Architect's Supplemental Instructions

Architect's ASI No: 009

Project:
Webster University
Interdisciplinary Science
Building

Date Issued: 08/01/2016

M0103.B

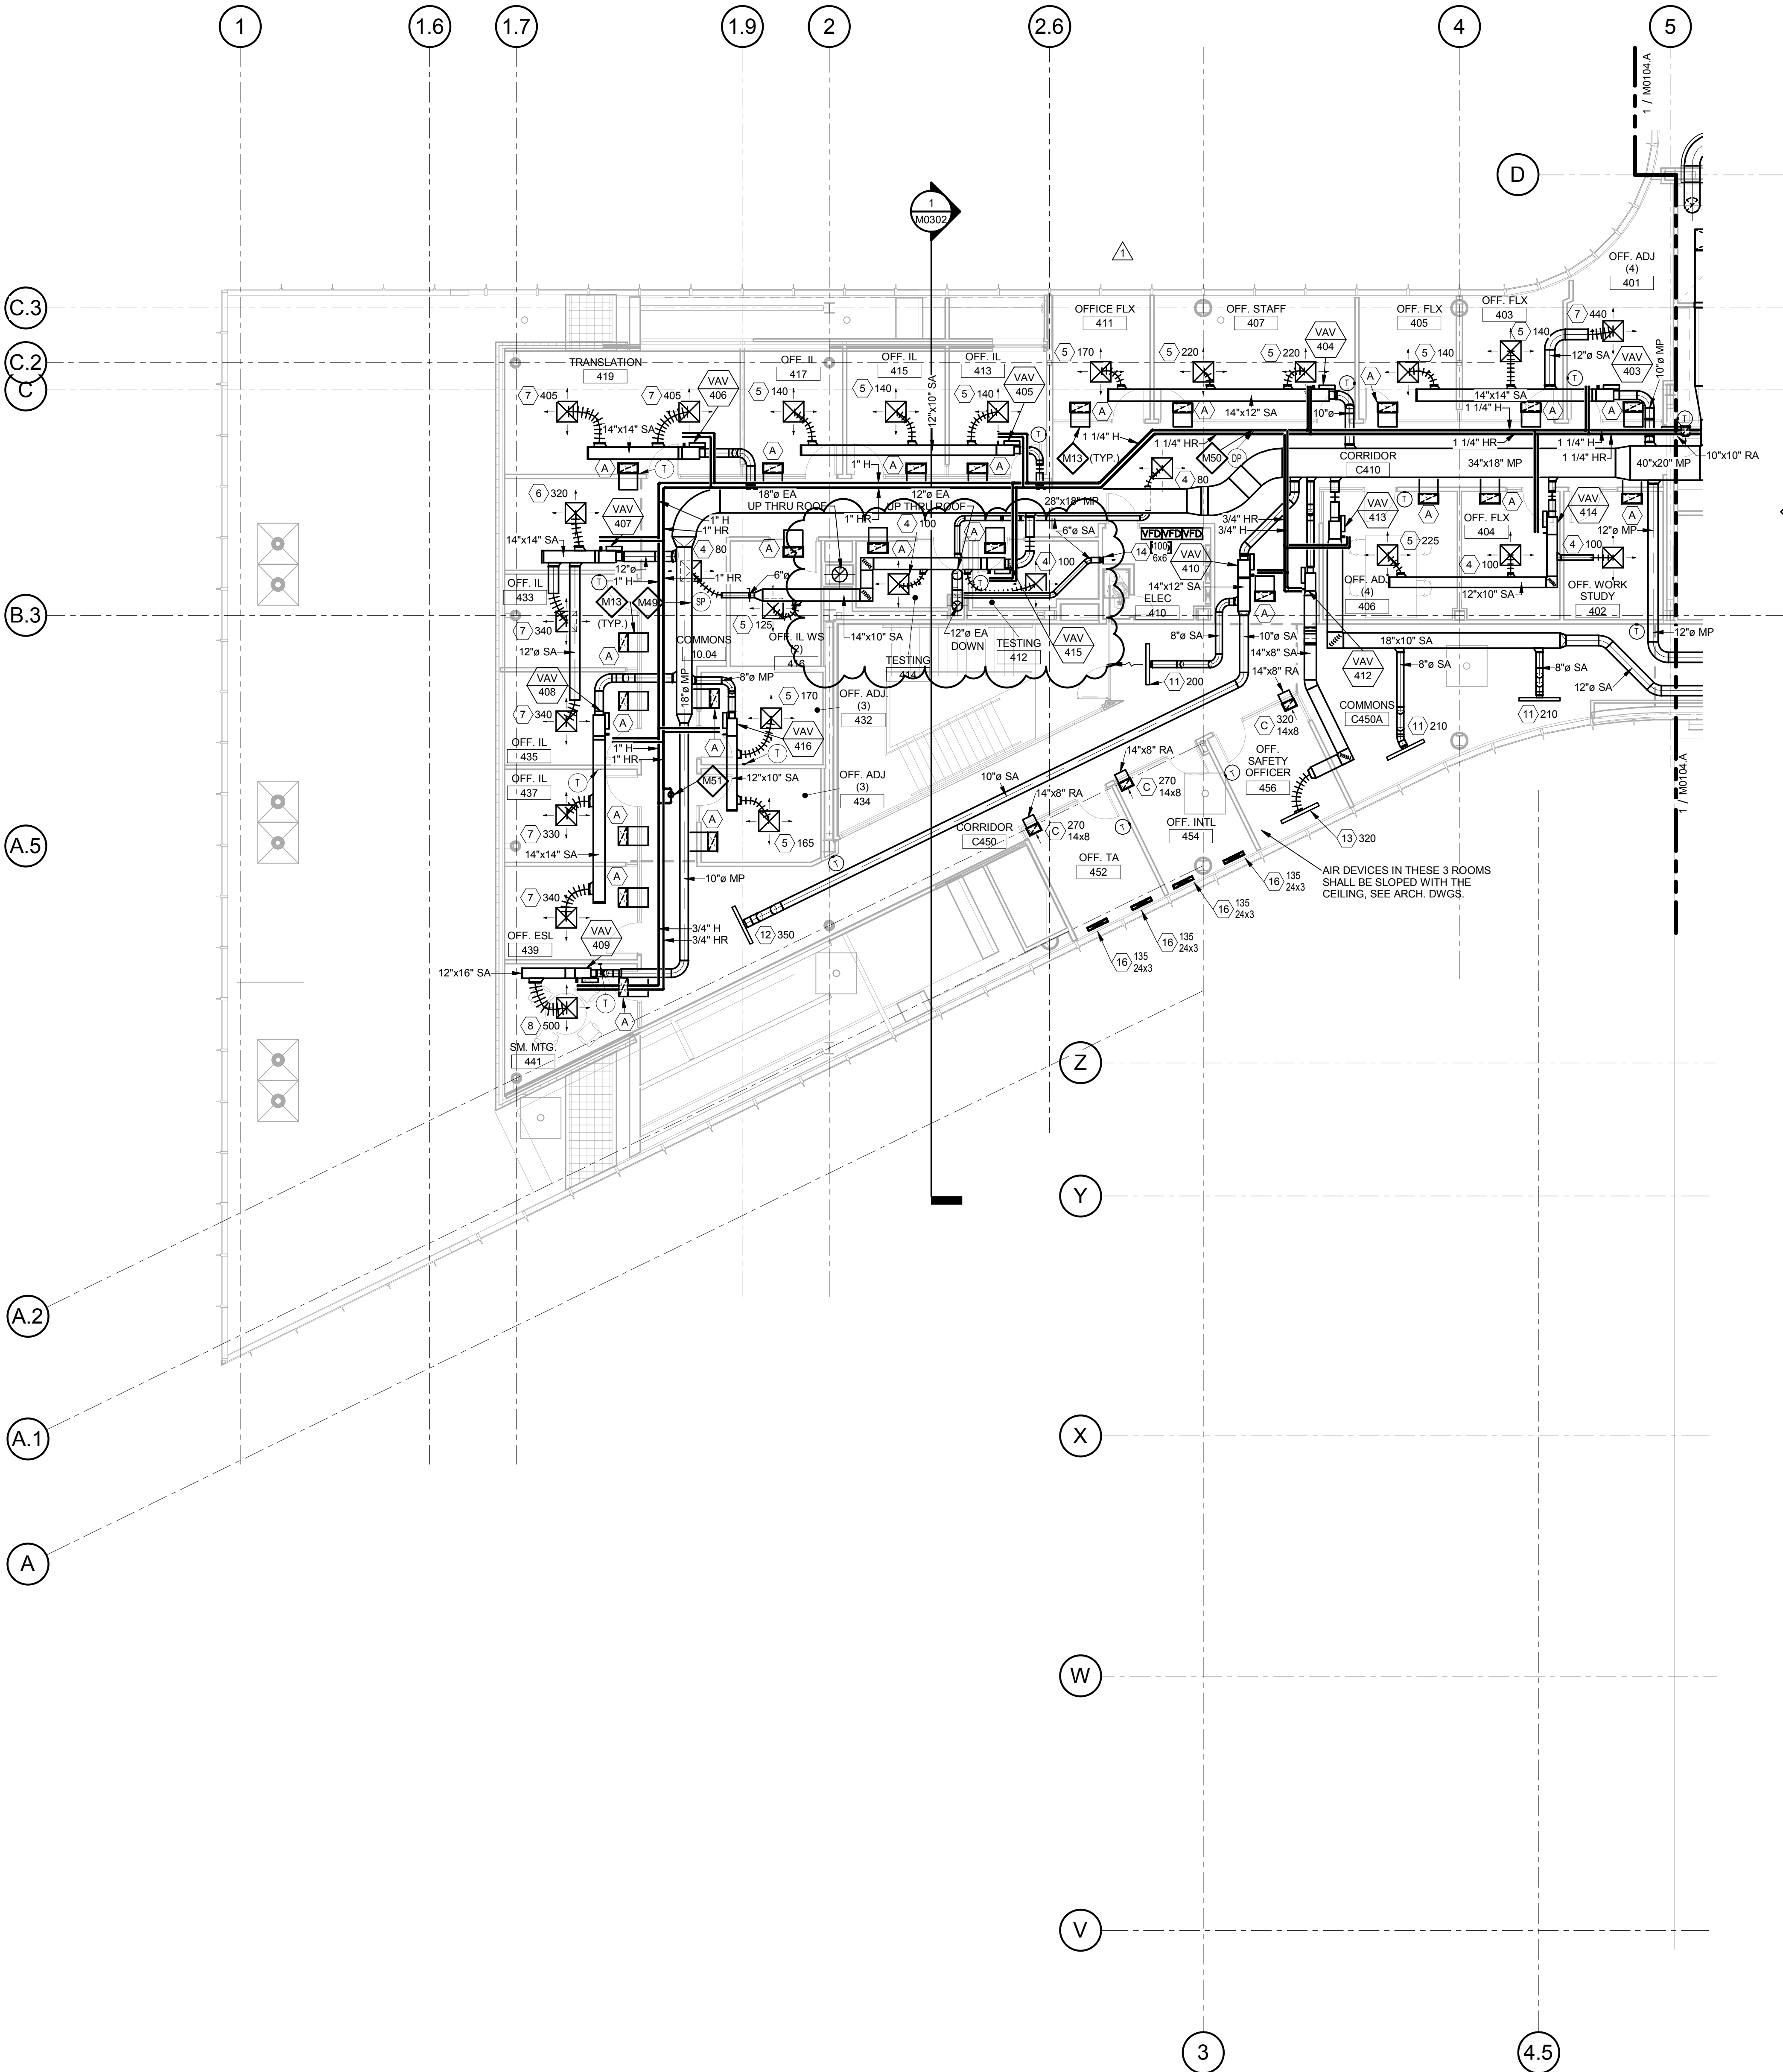
4. Mechanical Drawings: Modify location of exhaust riser from L01 and L02 near columns B.3 / 2 to coordinate with revised chase locations on the architectural drawings.
